*BEACON PLANNING BOARD*  
*One Municipal Plaza - Courtroom*  
*BEACON, NEW YORK 12508*  
*Phone (845) 838-5002 Fax (845) 838-5026*

**City of Beacon Planning Board**  
**10/10/2018**

**Re: Roundhouse – 2 East Main Street**  
*Site Plan Application – Responses to Comments*

Re: Site Plan and Special Permit for Roundhouse at Beacon Falls  
Tax parcels: 6054-30-171812 ( $\pm 2.15$  acres): City of Beacon, New York  
6054-30-195787 ( $\pm 6.76$  acres): City of Beacon, New York

Sheet 1 of 19

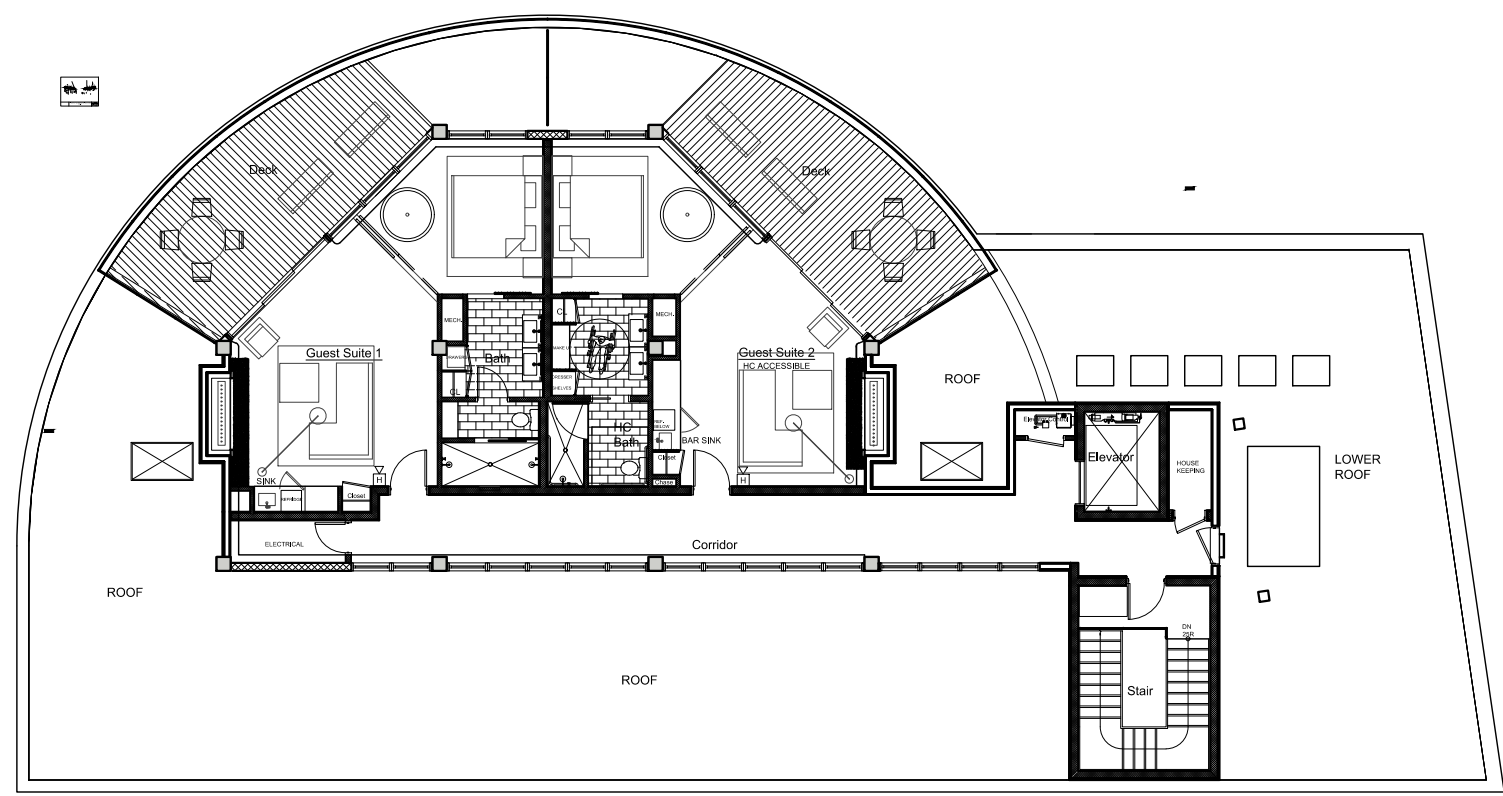
1. There are 175 spaces now show on the site plan. Ten spaces were added along the widened drive off of East Main Street. There were 165 spaces previously shown. 173 spaces are required.

2. Since 10 spaces were added along the drive off of East Main Street, it is no longer necessary to provide any parking off site.
3. The Site Plan notes that the 46 landbanked parking spaces will be constructed if and when the City of Beacon Building Inspector calls for them to be built out. There has been no need to do so in the years since the project was originally approved and occupied. An agreement will be drafted between the Applicant and the City regarding the landbanked spaces. The agreement will be submitted to the City Attorney for review and approval.

2nd Floor Plan

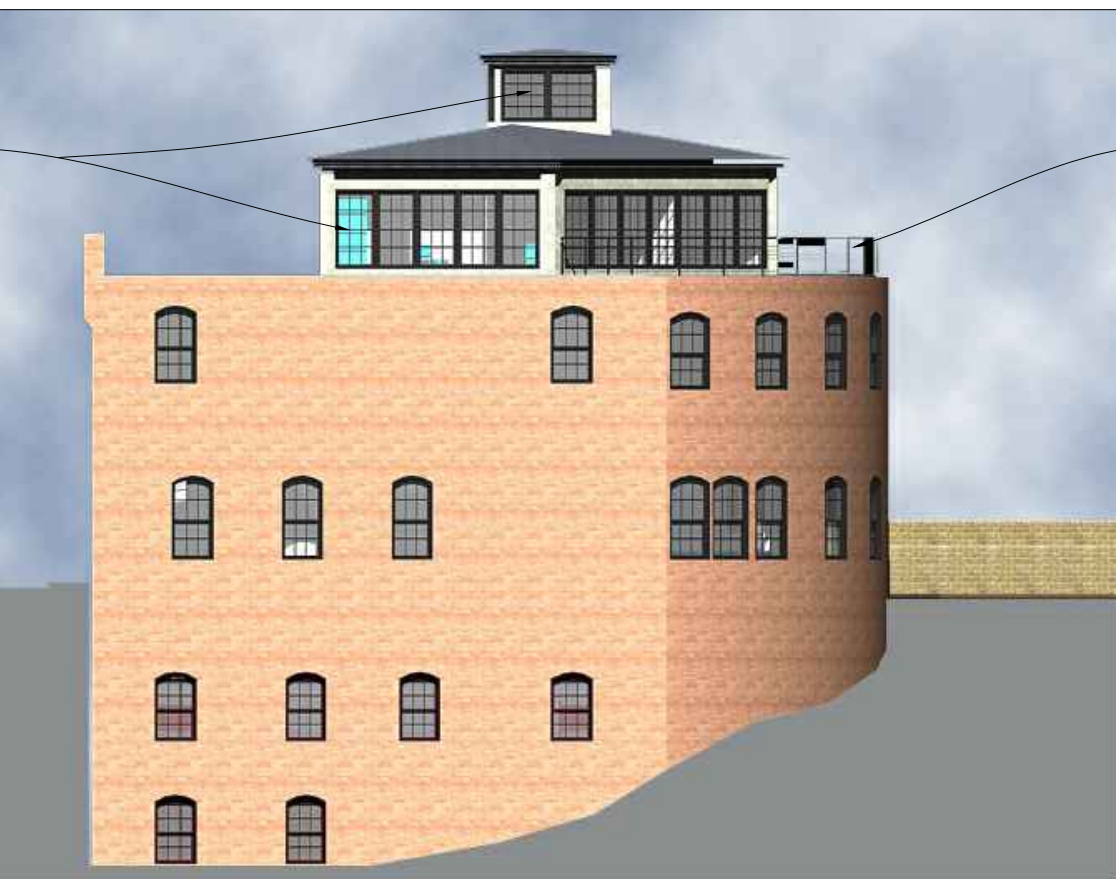
REPLACE PRIVATE DINING ROOM WITH HOTEL ADMINISTRATION OFFICE SPACE.

PARKING COUNT IS REDUCED BY 12 SPACES AS A RESULT OF ELIMINATION OF PRIVATE DINING ROOM.

NO ADDITIONAL PARKING IS REQUIRED FOR THE HOTEL ADMINISTRATION OFFICE SPACE

**Sheet 4 of 5 (Construction Details):**

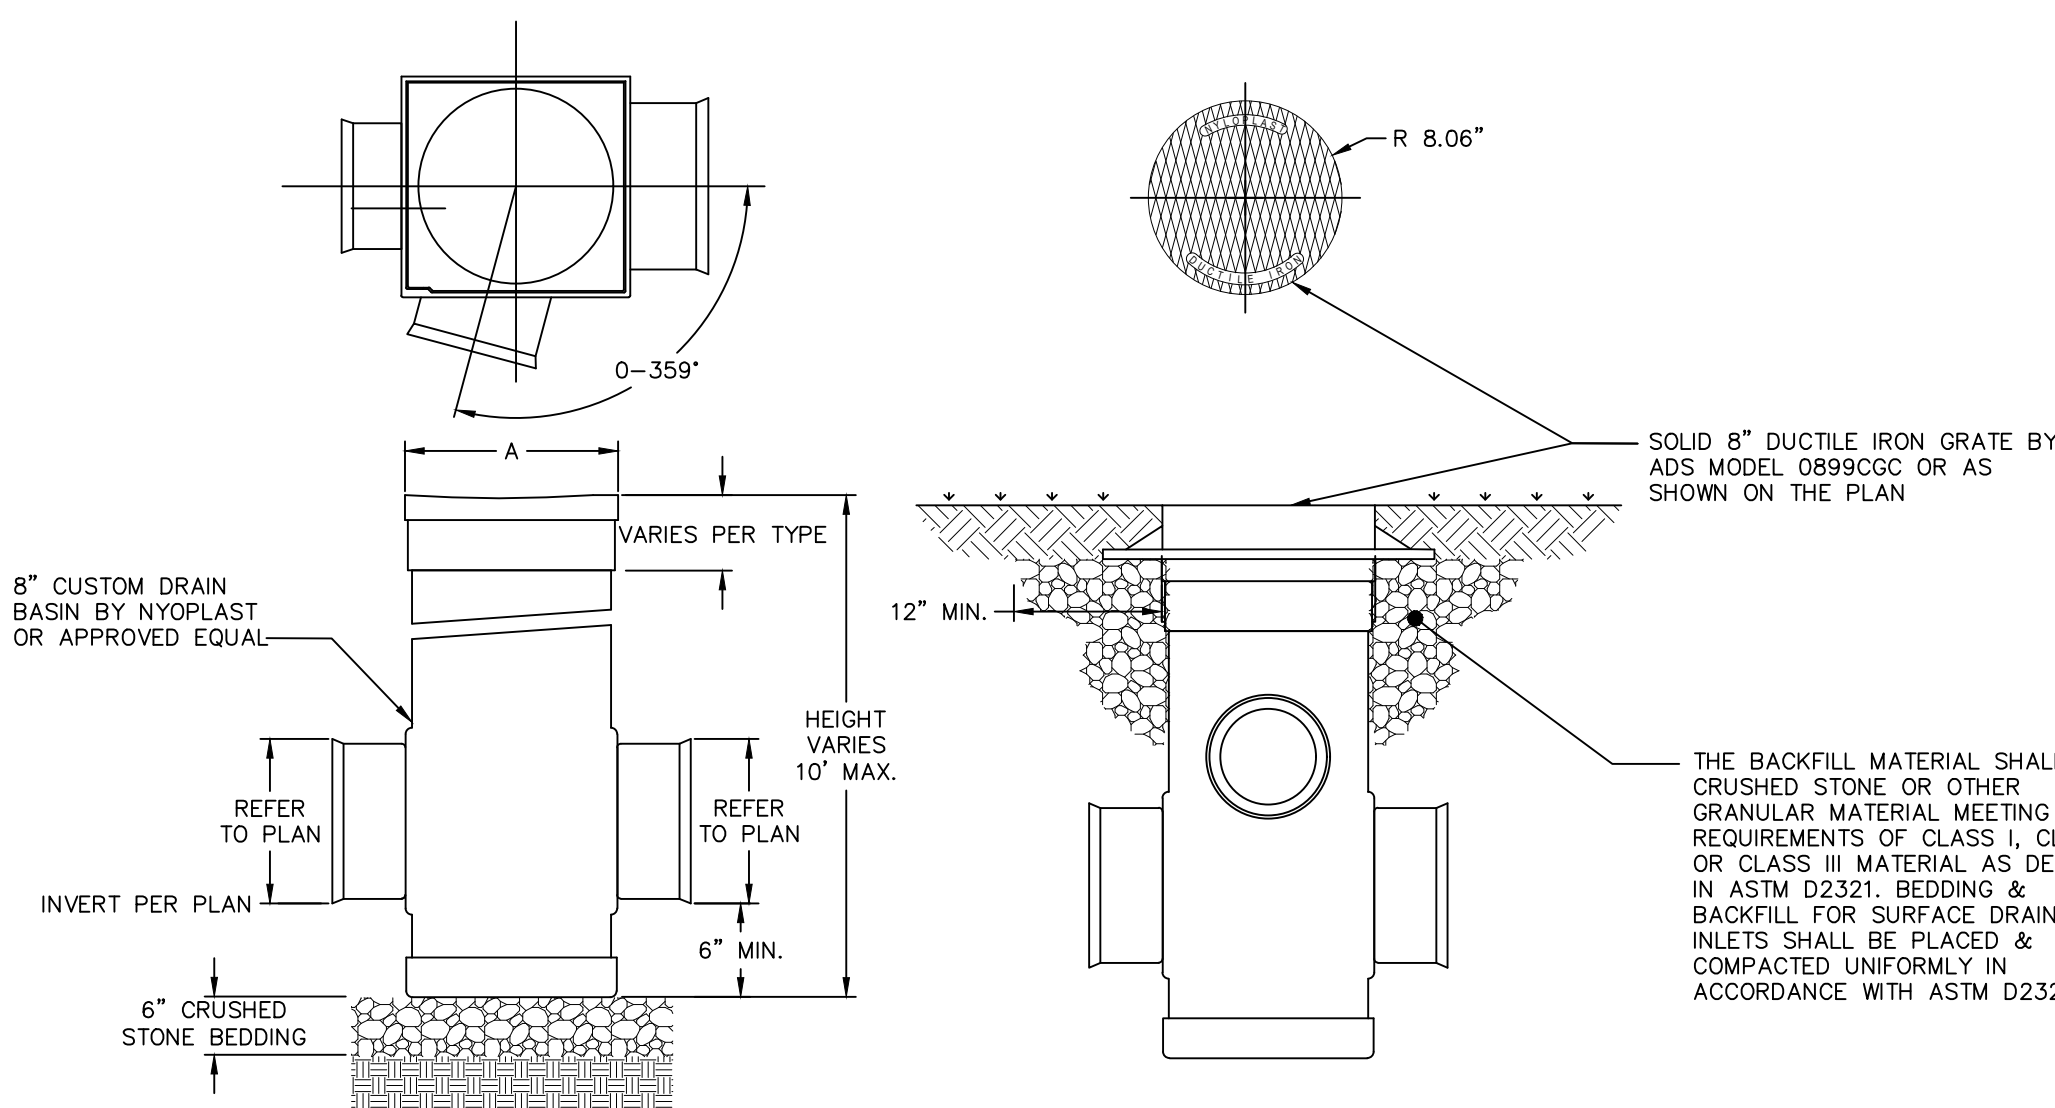
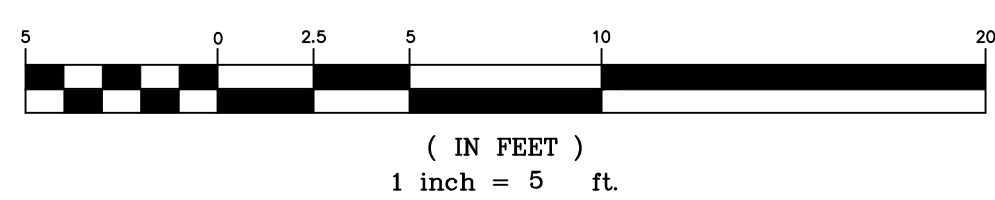
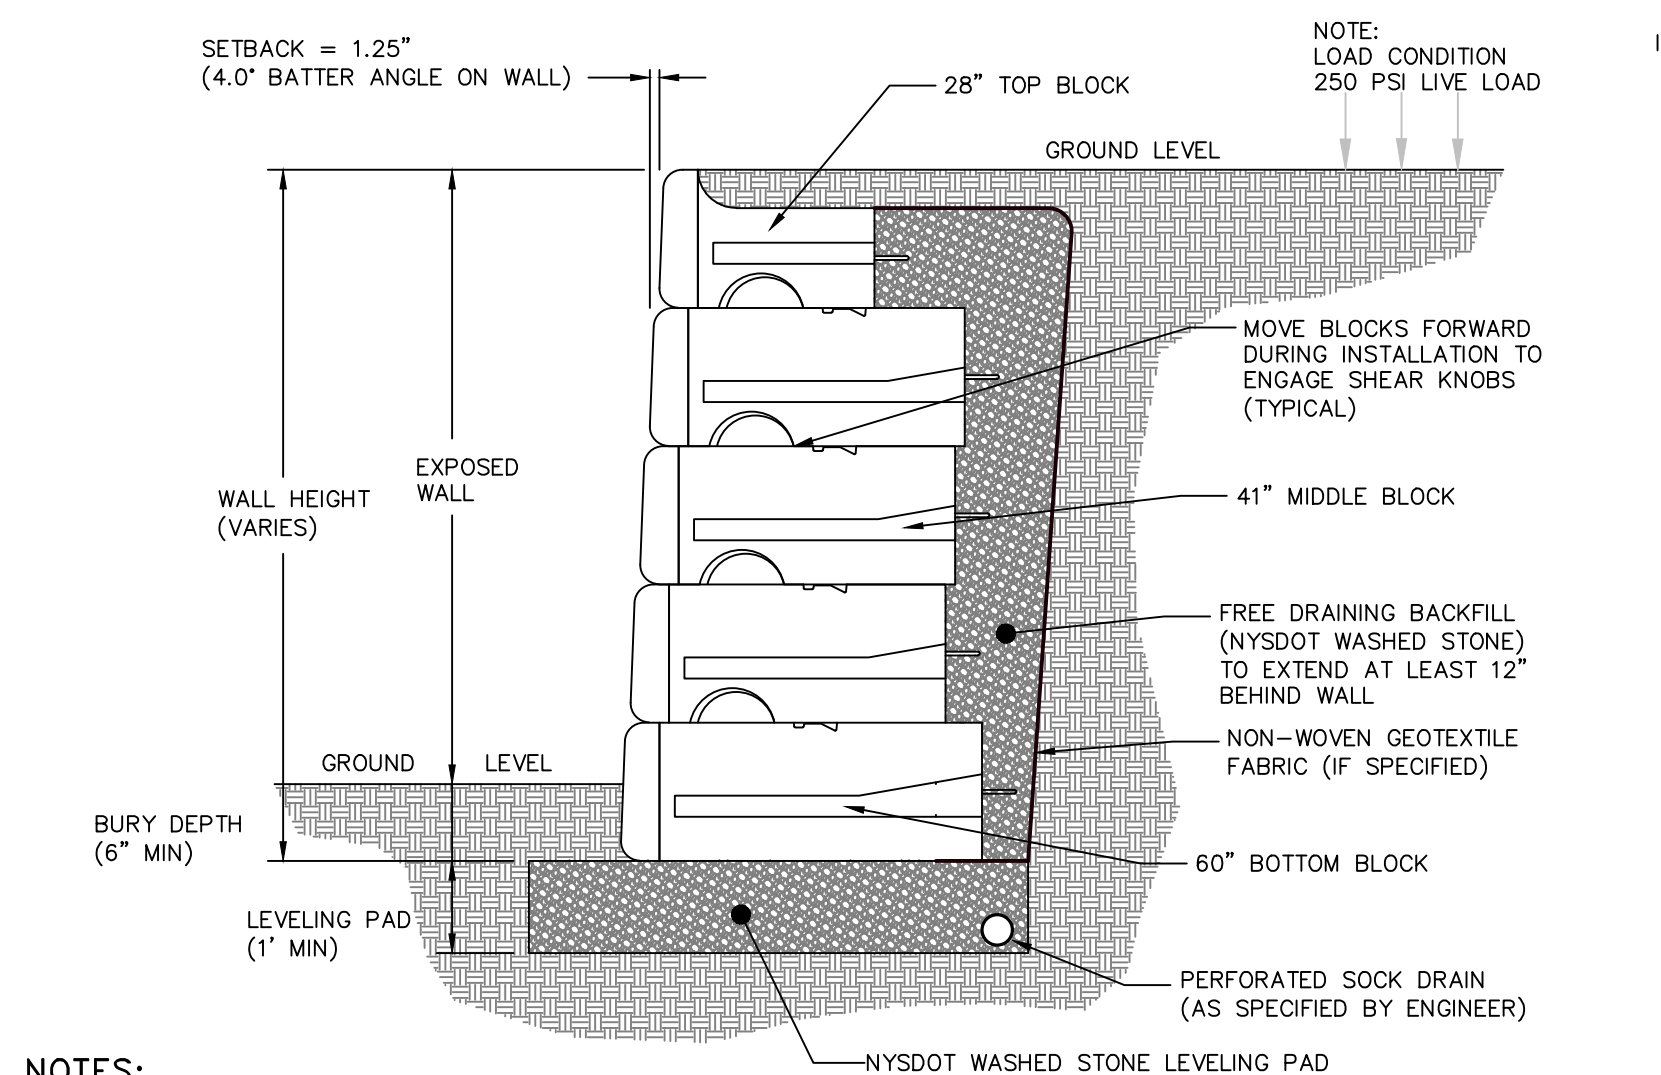
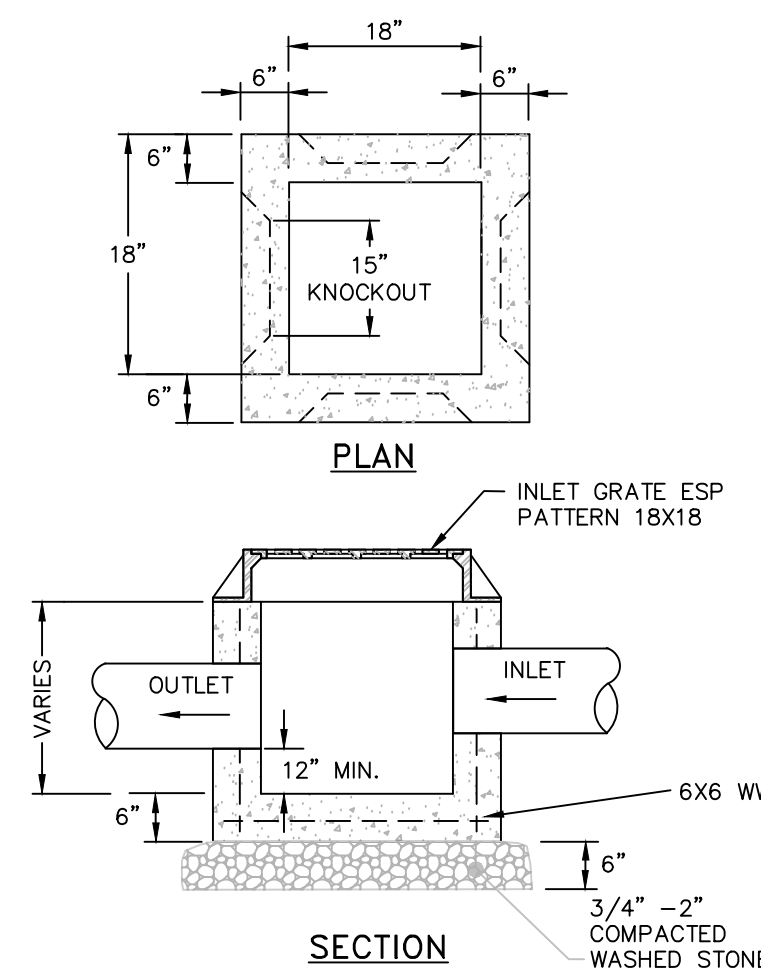
1. A Rain Garden Planting Plan has been added to Sheet 4.
2. Construction Details for the proposed retaining wall and Parapet wall have been added to Sheet 4.

3. The Driveway Detail has been edited to display 3" pavement section of top course.
4. A concrete yard drain was added as the inlet structure on the plans and a yard drain detail was added to Sheet 4.
